**MORE PEOPLE BIKING
MORE OFTEN**

Moving on Marion 2020 Recommendations

Marion - Right Hand Parking Protected Bike Lane

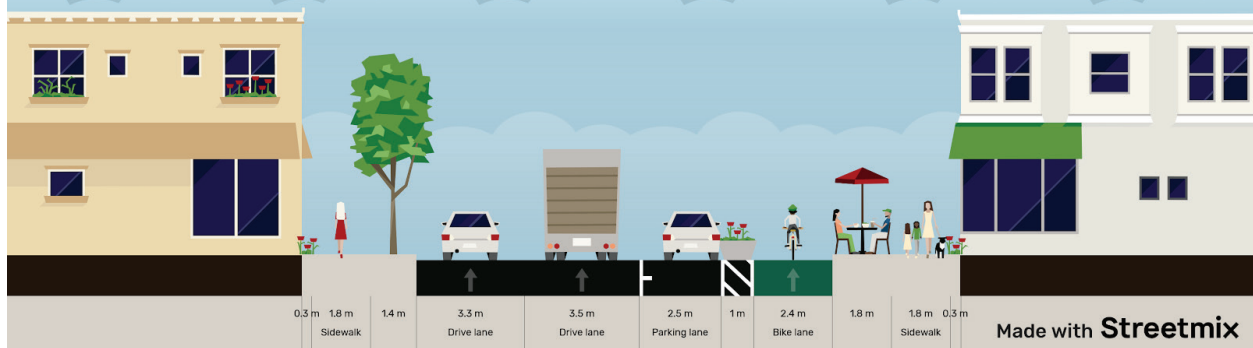
Having the protected bike lane on the same side of the road as the protected bike lane allows for a sufficient setback at intersections to allow vehicles to exit the travel lane before crossing the bike lane perpendicular to its direction of travel, improving safety for people on foot or bike at these intersections by maximizing visibility of people on bike to those in vehicles.

A 1m buffer between the parking lane and the protected bike lane provides clearance between opening doors and the bike lane, but can also be dropped to the same level as the bike lane in areas where accessible parking is desired. In this configuration, a 2.2m clear space would be provided for loading/unloading passengers next to the parking lane while still leaving a 1.2m of space in the bike lane for maneuvering.

Marion - Right Hand PPBL - Accessible Parking

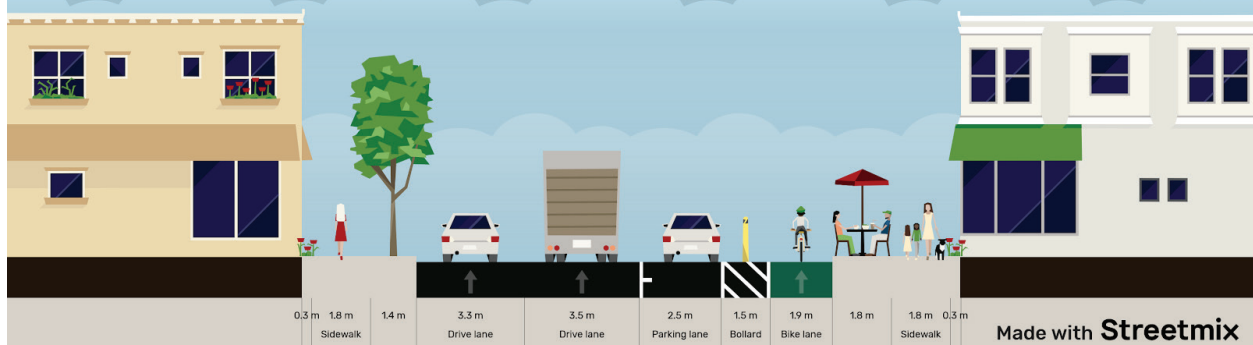
A sidewalk buffer of at least enough width to allow for a curb ramp would allow for the provision of ramps in close proximity to storefronts and other destinations. An intermediate height bike lane would help minimize the width required for the sidewalk buffer to accommodate any mid block curb ramp used to provide access between the sidewalk and bike lane. This configuration allows most (if not all) parking spaces to be accessible.

Marion - Right Hand PPBL @ Pull-out Bus Stop

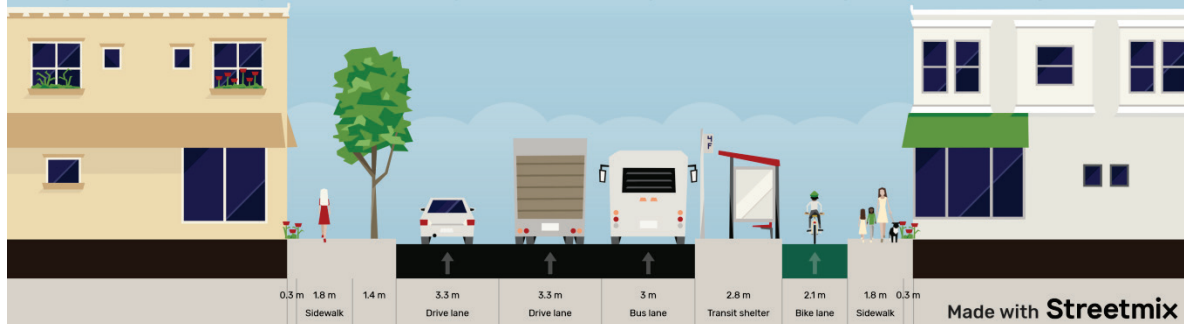
Where pull-out bus stops are used, they should be paired with transit priority signals.

Recommended Local Bike Network

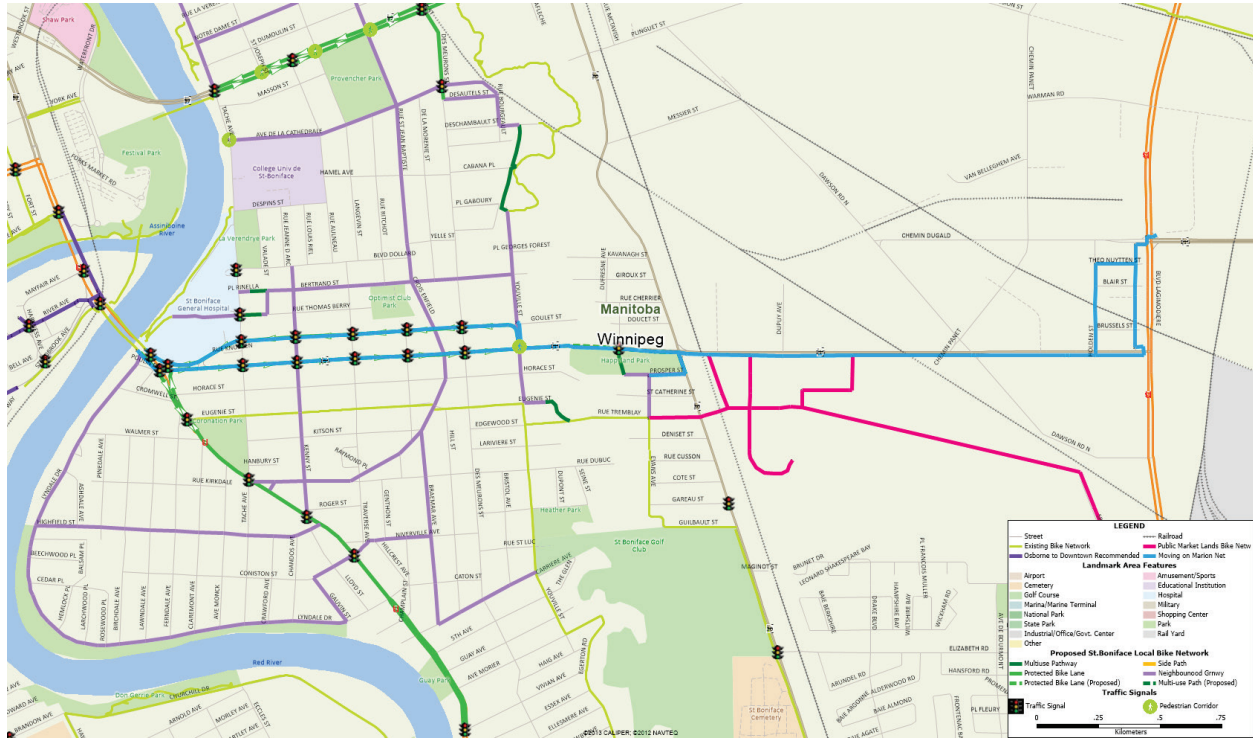
The success of any cycling facilities on Marion/Goulet will ultimately be tied to their ability to provide safe, convenient, and direct connections to local and regional destinations and through the corridor. Below is a recommended local bike network for the area north and south of the Marion Corridor.

While this local bike network plan indicates a number of planned or potential neighbourhood greenways where we would like to see resources prioritized to improve bikeability, all streets should accommodate pedestrian and bicycle traffic.

Tremblay Underpass

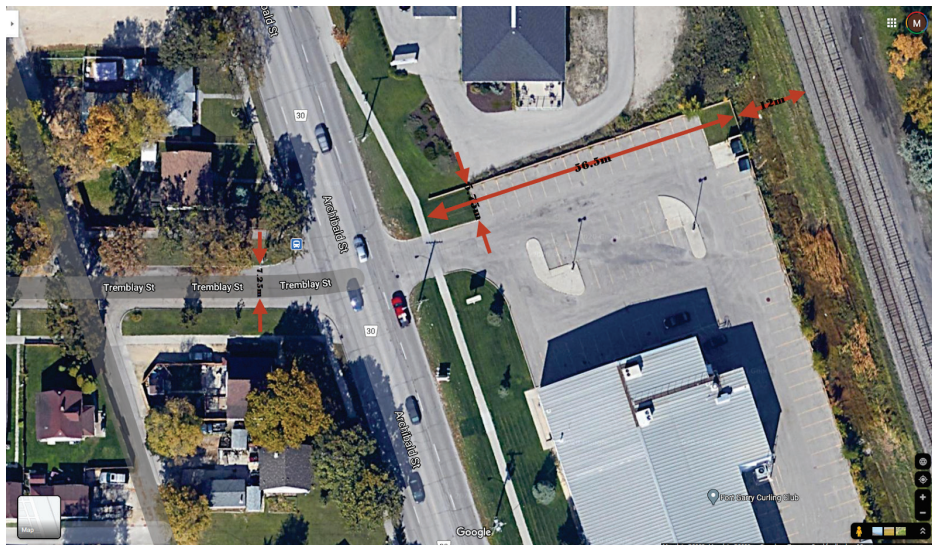
- Would require a half signal at Archibald @ Tremblay
- Takes out at least 17 parking spots from Fort Rouge Curling Club parking lot.
